# 1. SBR 2<sup>nd</sup> level warning

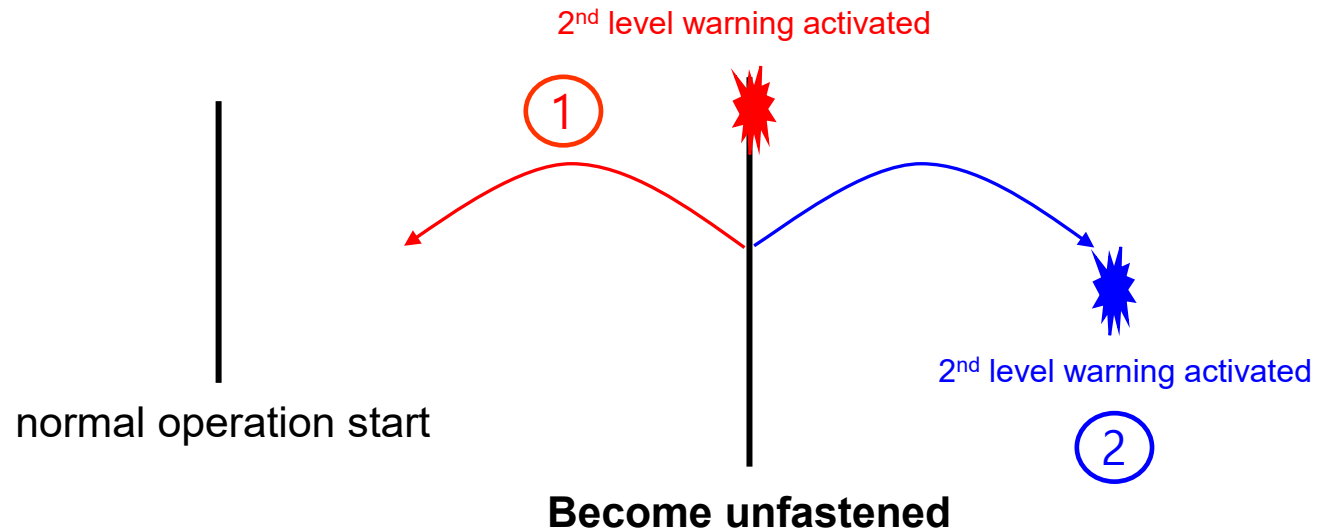
8.4.3.3. The second level warning shall be activated when a safety-belt is or becomes unfastened while the vehicle is in normal operation and while, at the same time, any one condition or any combination of the conditions, at the choice of the manufacturer, set out in paragraphs 8.4.2.4.1.1. to 8.4.2.4.1.3. is satisfied. > (1)

8.4.2.4.5. For the condition that a safety belt becomes unfastened pursuant to paragraphs 8.4.3.3. and 8.4.4.5., the thresholds set out in paragraphs 8.4.2.4.1.1. to 8.4.2.4.1.3. shall be measured from the point in time at which unfastening occurs. > (1) or (2)?
